# Get the Fit You Need

New, improved generator has red shroud

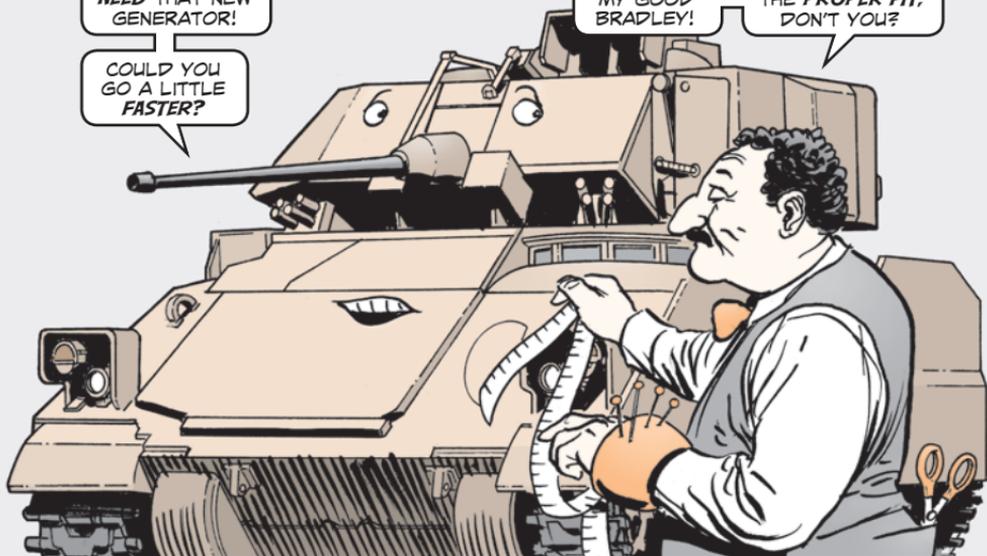
**W**hen the time comes to replace the generator on your Bradley, fit is pretty important! If you're trying to install a Niehoff 400-AMP generator, NSN 6115-01-562-6264 (PN 12386631-1), you could run into problems. The generator's housing may come into contact with the transmission output housing oil port plugs. That keeps you from bolting it in place properly.

A new generator is available that was designed to fit much better. Problem is, it still has the same NSN and part number as the ill-fitting generator. The only way to tell the two generators apart is by the color of the fan shroud and the addition of a safety decal.

The new and improved generator has a red fan shroud. If your generator has a black shroud, replace it.
